Compliance with Quarry Regulations assessed by James Associates Geophysical Consultants, 3 Snitterton Road, Matlock DE4 3NA

PROJECT:	
Ballswood Quarry	
TITLE:	
Typical Sections through Proposed Extension Areas A & B	
REF NO:	
KD.BLWQ.2.D.016A	
DATE:	SCALE:
June 2022	1:1,000 @ A3
STATUS:	
FINAL

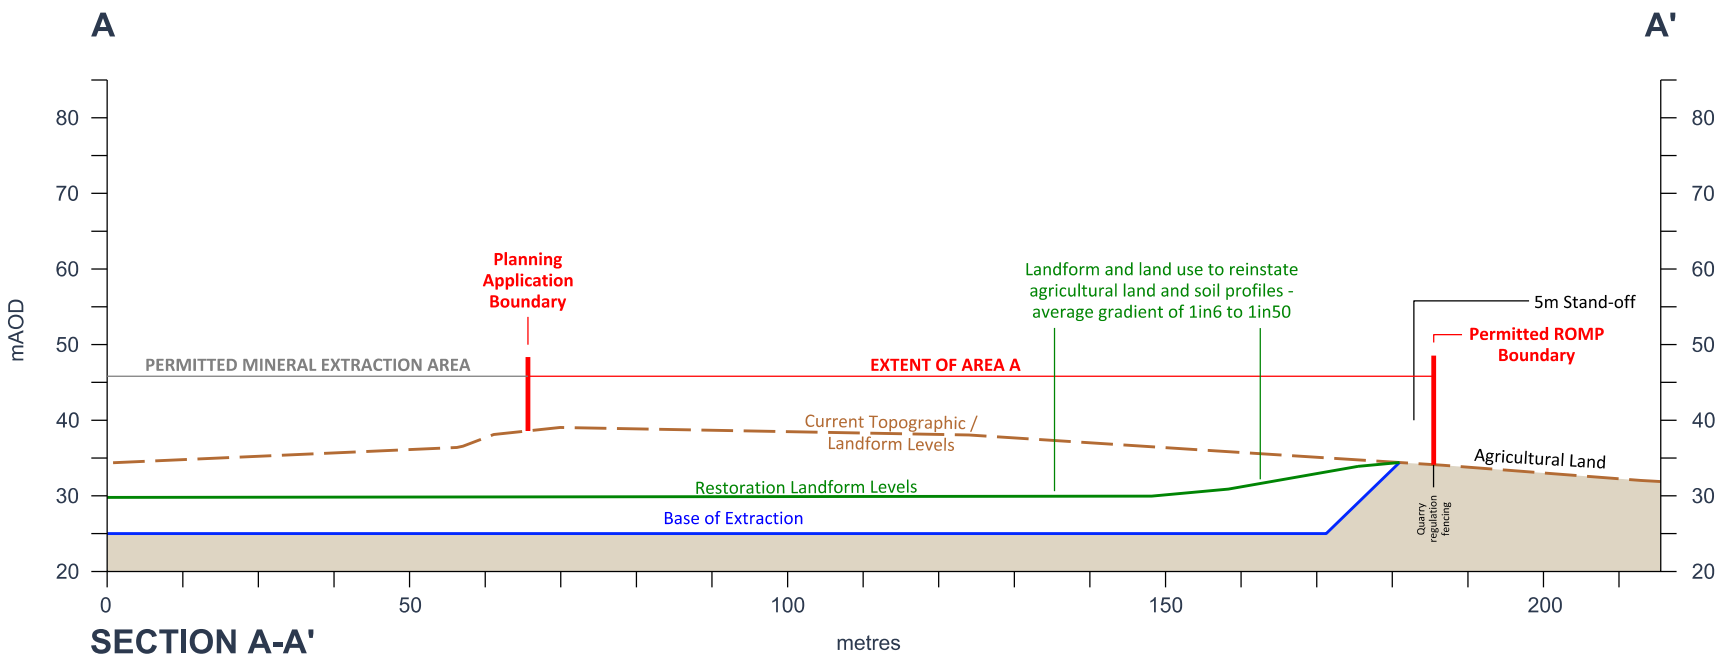
Proposed Area B - Section B-B'

This area is remote from any features lying outside of the site boundary which would be significantly impacted should slope instability extending beyond the boundary occur.

The proposed relatively low face heights which will be excavated, between 5.8 and 11.8 metres and slope gradient of 1 vertical to 1 horizontal [45 degrees] is unlikely to result in significant instability developing and affecting land beyond the site boundary. This assumes that a stand-off from the site boundary to limit of extraction at surface is at least 3 metres.

It is likely that short term excavation slopes with a gradient of 1 in 1 will remain stable though are un-likely to do so in the medium to long term. Therefore, sections of excavated slope should be rapidly infilled against to create the proposed long-term 1 vertical to 3 horizontal restoration profile.

The infilling / final restored slope construction should be undertaken by tipping in layers of approximately 500mm, tracking-in by dozer and ADT's and construction from the base upwards. End-tipping should not be permitted in the construction of the restored slope.

Proposed Area A - Section A-A'

It was originally proposed to construct a slope with a maximum excavated height of 47 metres, extending from approximately 72mAOD to 25mAOD, at an overall gradient of 1 in 1.0.

To date on site the maximum excavated overall slope height is approximately 30 metres. The maximum excavated slope heights are in the southern quarry void, specifically the northern face which lies adjacent to the main ramp, the other along the western boundary. The overall slope gradients for these faces are 1 in 1.3 and 1 in 1.7 respectively.

Both profiles have shown good stability with only localised , water related, minor scouring / collapse.

To accurately define an excavated slope profile, further works in the area are being undertaken. Until this work has been completed, it should be assumed that the maximum extraction face slope profile should be no steeper than 1in3 to provide appropriate stability.

The Operator has confirmed that all Geophysical reports / Quarry Regulations will be fully implemented.

If on the completion of further geophysical assessment it is confirmed that mineral can be extracted to the currently stable 1 in 1.3 slope, this information would be submitted to Wrexham County Borough Council Public Protection, Planning Control / Planning Department for consideration.
